Re: RPRC Application No.: 2021-0137
9 Seymour Place East
Town of North Castle

We have received the RPRC return letter dated March 2, 2021 and offer the following responses:

STABILIZED CONSTRUCTION ENTRANCE (ANTI-TRACKING PAD) N.T.S.

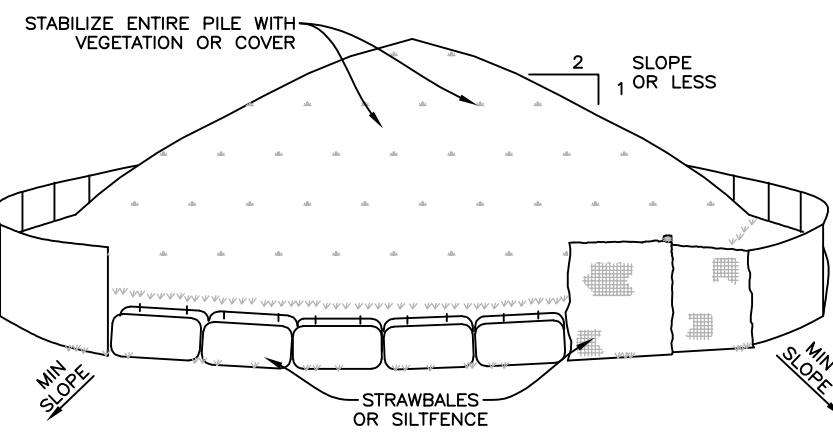
Comment 16. Include erosion control measures on the plan, including, but not limited to, temporary construction access and construction sequence, etc. Provide details.

Response 16. Additional erosion control measures were added to the site plan. The construction sequence was clarified on the plan.

CURTAIN DRAIN DETAIL N.T.S.

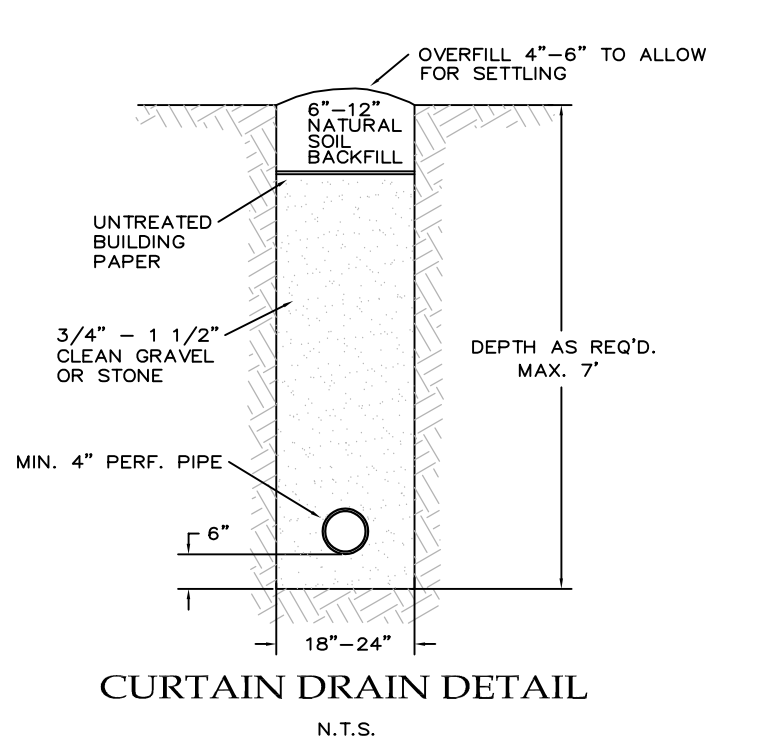
Comment 15. The proposed curtain drain, and proposed infiltration system overflow shall be connected into a single junction point onsite prior to the connection to the existing catch basin in the Town right-of-way. The plan shall be revised accordingly. Provide details.

Response 15. The site plan was revised to connect the 2 outfalls into a single connection to the existing catch basin.

FOOTING DRAIN OUTLET PROTECTION DETAIL N.T.S.

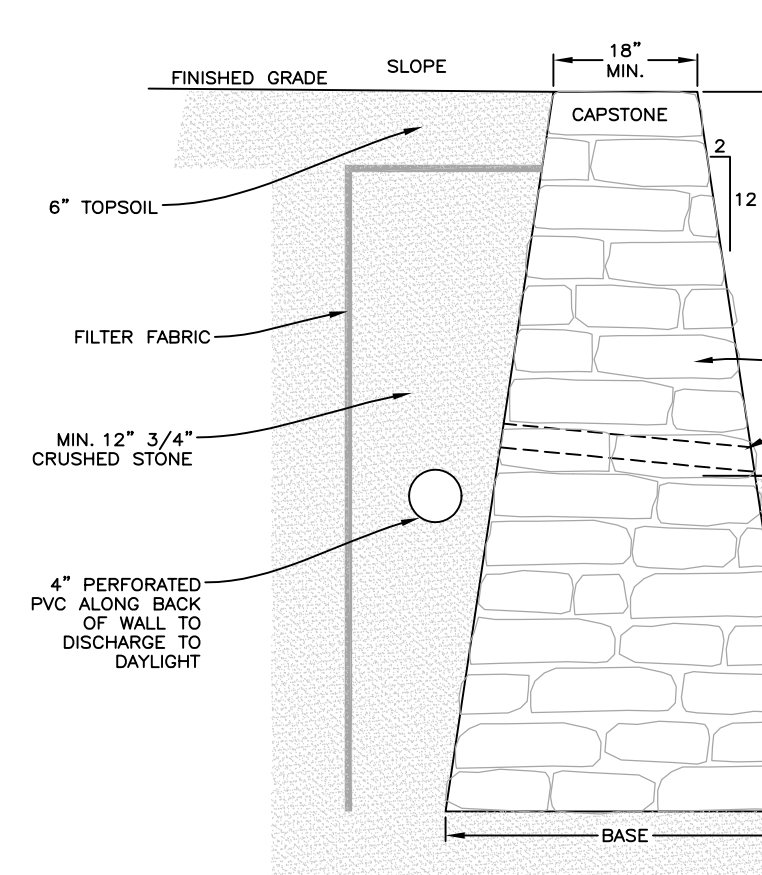
Comment 5. The plan shall illustrate a stabilized outfall for the proposed footing drain outfall. Provide detail.

Response 5. Stabilized outfall for the proposed footing drain is provided.

PROPOSED DRIVEWAY PROFILE HORIZONTAL SCALE: 1" = 20' VERTICAL SCALE: 1" = 5'

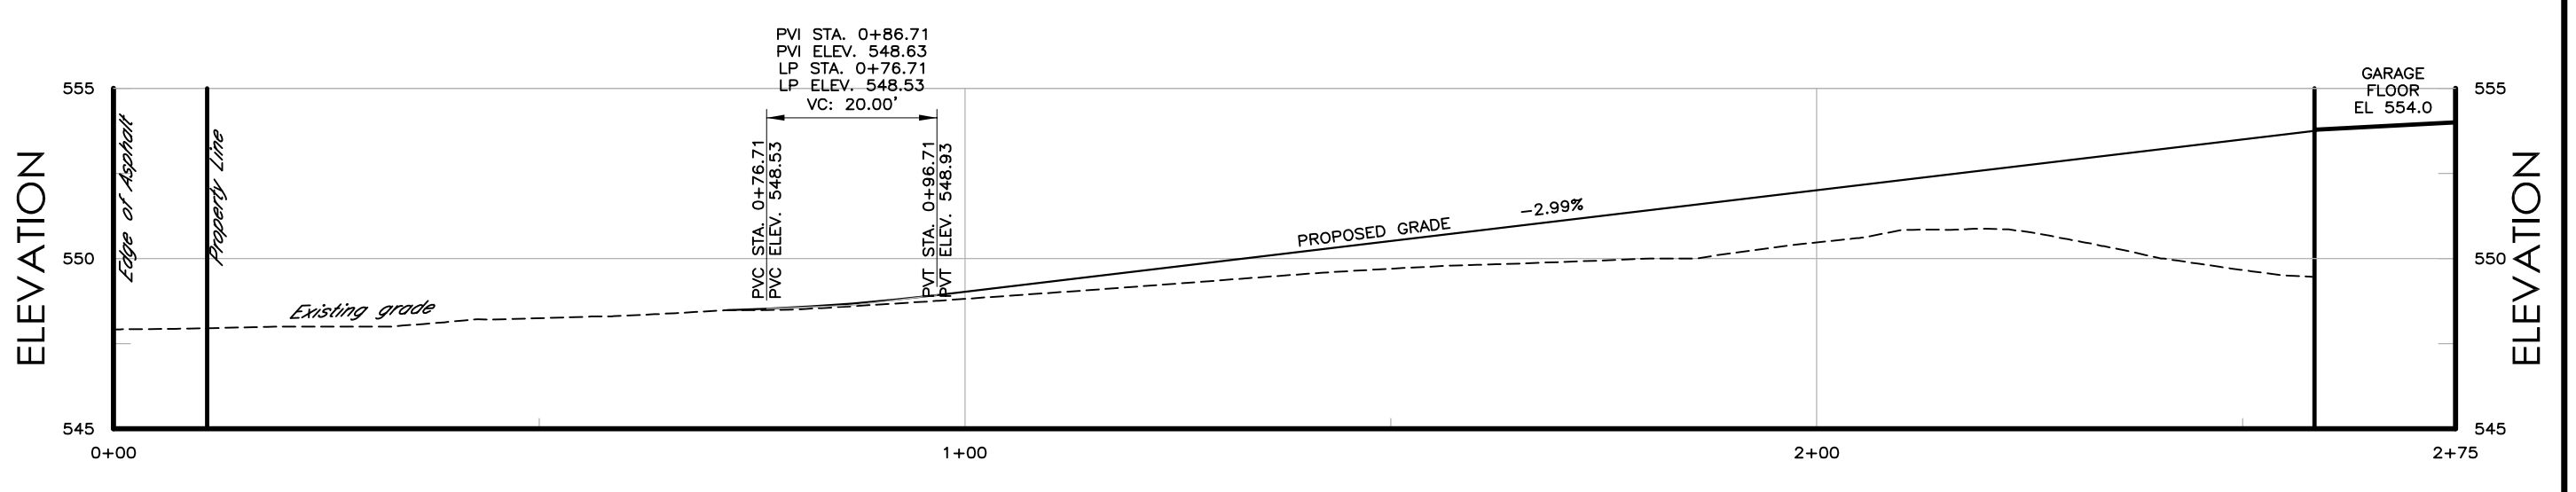
Comment 6. The proposed driveway profile shall be extended to the existing edge of pavement on the Town right-of-way. The profile shall include the appropriate vertical geometry.

Response 6. The proposed driveway profile has been clarified.

PAVEMENT REPLACEMENT N.T.S.

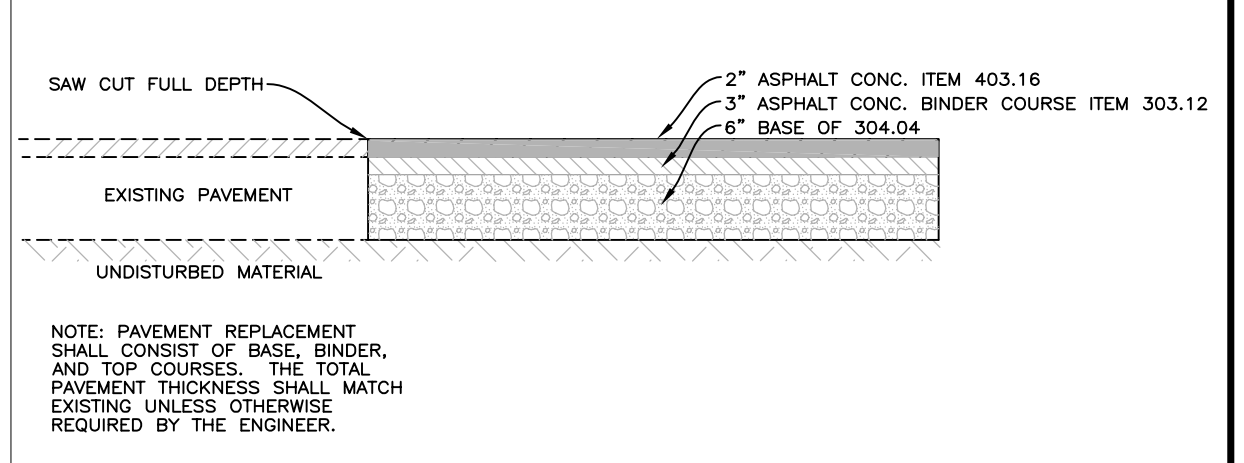
Comment 17. The plan shall illustrate the following details: o Pavement Restoration Detail o Asphalt Curb Restoration Detail.

Response 17. The site plan has been revised to include these details.
